[FI] S.16 Planning Application No. A/YL-KTN/1107 - Further Information

3rd Further Information

Proposed Temporary Place of Recreation, Sports or Culture (Hobby Farm) with Ancillary Facilities and Associated Filling of Land for a Period of 5 Years in "Agriculture" Zone, Lots 1058 RP, 1059 RP, 1060 and 1061 in D.D. 107, Fung Kat Heung, Kam Tin, Yuen Long, New Territories

(S.16 Planning Application No. A/YL-KTN/1107)

GEO Technical Guidance Note No. 43 (TGN 43) Guidelines on Hydraulic Design of U-shaped and Half-round Channels on Slopes

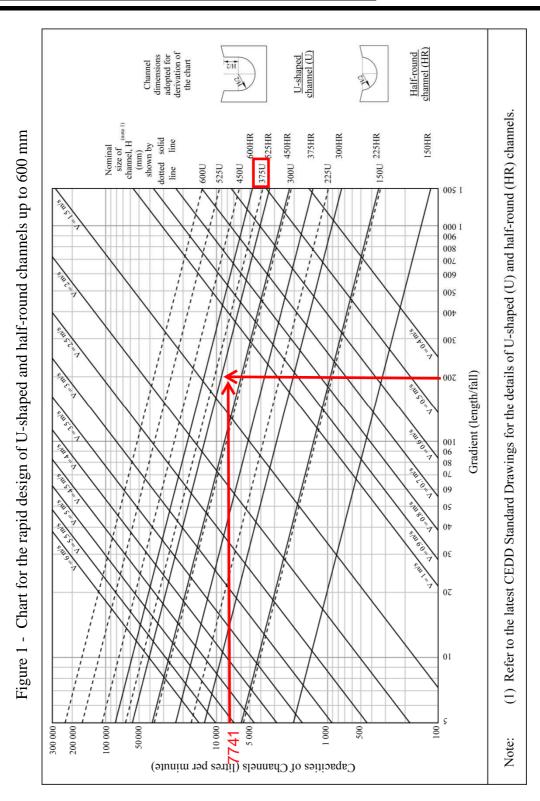
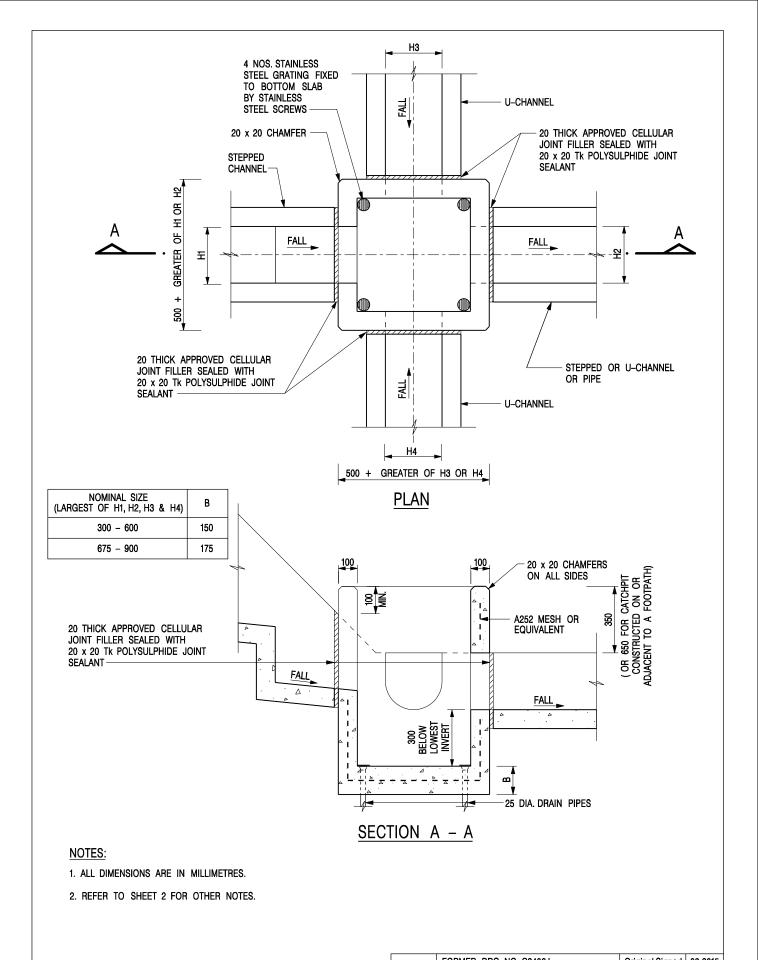
1. (1. Comments of the Chief Engineer/Mainland North, Drainage Services Department (CE/MN, DSD)								
(a)	GEO Technical Guidance Note No. 43 should be adopted for u-channel checking as Figure 8.7 of the Geotechnical Manual for Slopes (GCO, 1984) was superseded.	TGN 43 is adopted.							
(b)	Calculation – For rainfall intensity, please review the a, b and c values according to the latest SDM Corrigendum.	Table 3a, 50 years return period under corrigendum 2024 is adopted.							
(c)	Please advise if any site formation/ land filling works to be carried out under this application. Please note that the overland flow from the adjacent lands should not be affected.	Minor filling will be carried out for leveling the application site to facilitate the proposed development.

Calculation of Runoff from the Proposed Development, $= 0.278 \,\mathrm{CiA}$ The site will be hard praved = 0.95 m^2 = 1362 km^2 = 0.001362 $= 0.14465 \text{ L/ H}^{0.2} \text{A}^{0.1}$ $= 0.14465*10/1^{0.2}*1362^{0.1}$ = 0.703min i (Values of a, b and c are from Table 3a of $= a/(t+b)^c$ Corrigendum 2024, SDM with 50yrs return period) $= 505.5/(0.703+3.29)^{0.355}$ = 309 mm/hr Therefore, = 0.278*0.95*309*0.001362*1.16 (16% for rainfall increase due to climate change) = 0.1290m³/sec lit/min = 7741

Check 375mm dia. Pipes by Colebrook-White Equation

Gradient of Proposed 375mm dia. pipe: (5.425-5.3)/6.87, i.e. 1:55

$$V = -\sqrt{(8gDs)} \log(\frac{ks}{3.7D} + \frac{2.51v}{D\sqrt{(2gDs)}})$$

where: V g D ks v s	= = = = =	9.81 0.375 0.0006 1.14E-06 0.018182		mean velocity (m/s) gravitational acceleration (m/s2) internal pipe diameter (m) hydraulic pipeline roughness (m) kinematic viscosity of fluid (m2/s) hydraulic gradient	(Table 14 from SDM 2018, concrete pipe)
Therefore, design V of pipe capacity	=	2.4459	m/s	< 3 m/s	
Capacity of pipe		VA	=	3.14*0.175*0.175*2.6646	
Apply 0.9 factor for sedimentation	= =	0.173 9336	m3/s lit/min	> 7385 lit/min	OK
